FINAL DRAINAGE PLAN AND REPORT

16140 OLD DENVER ROAD

PCD File No. PPR-16-037

SUBJECT: Drainage Plan and Report All About Outdoor Storage PPR-16-037

Stormwater Detention and Infiltration Design Data Sheet

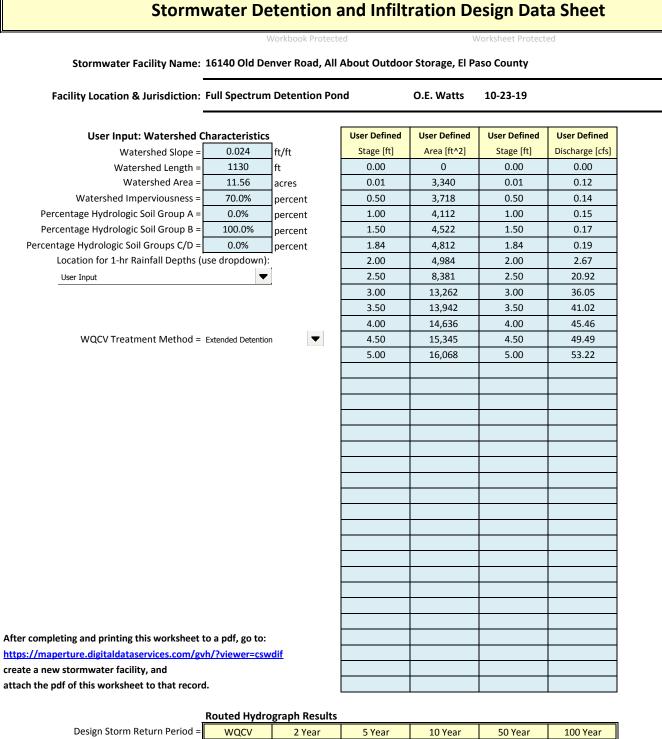
UD-Detention worksheet is missing. See review 3

6. METHOD for comment to the UD-Detention.
